Ward Ottery St Mary

Reference 19/1794/VAR

Location Land At Barton Orchard Tipton St John

Proposal Variation of Condition 2 (plans condition) to regularise changes made to the built development and variation of Condition 6 (landscaping scheme) of permission 15/2753/VAR (development of 15 no. houses).

Public open space to be provided to east of developed area as indicated below:

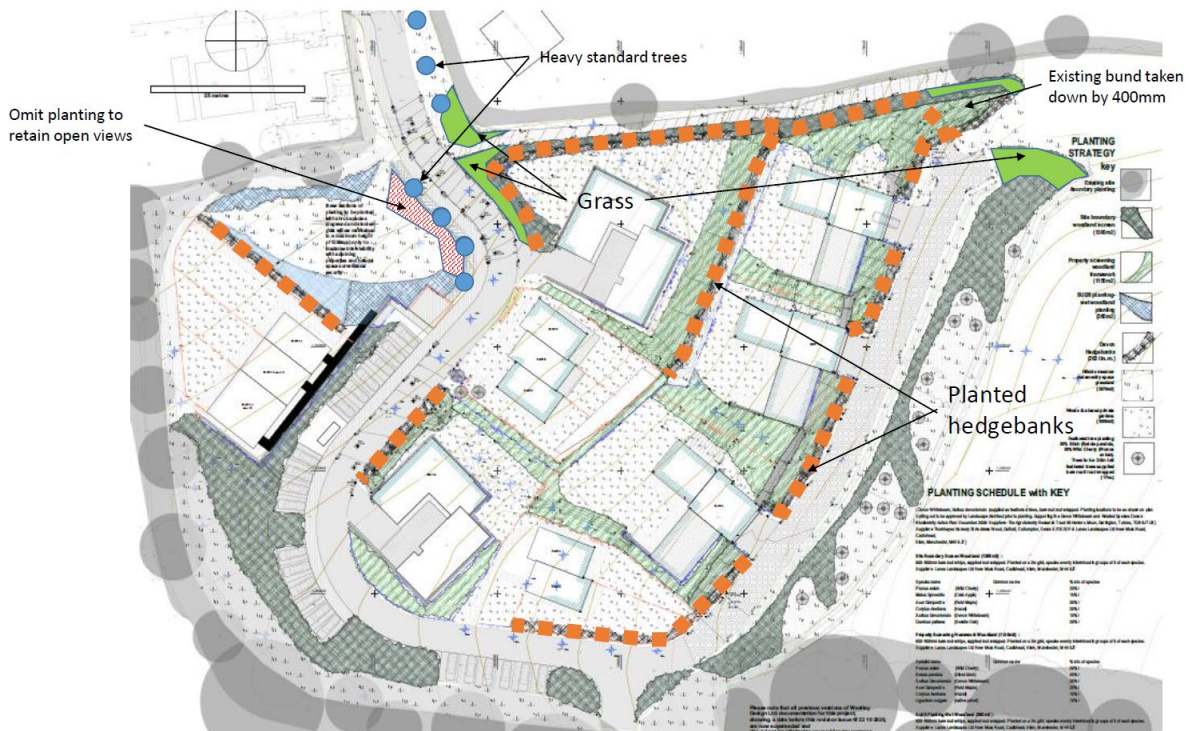
1.1 Public open space

Applicant to provide a site plan indicating the open space areas and detailed drawings and specifications to include:

- Details of wildflower mix and specification for ground preparation, sowing and establishment to area to be re-cultivated, specification for tree planting and bench supply and installation.
- Oak planting should comprise 3 no. *Quercus robur* supplied as 10-12cm girth standards planted as a group 3 metres apart.
- Footpath construction - this should include for provision of surfacing to the extent indicated by red pecked lines.
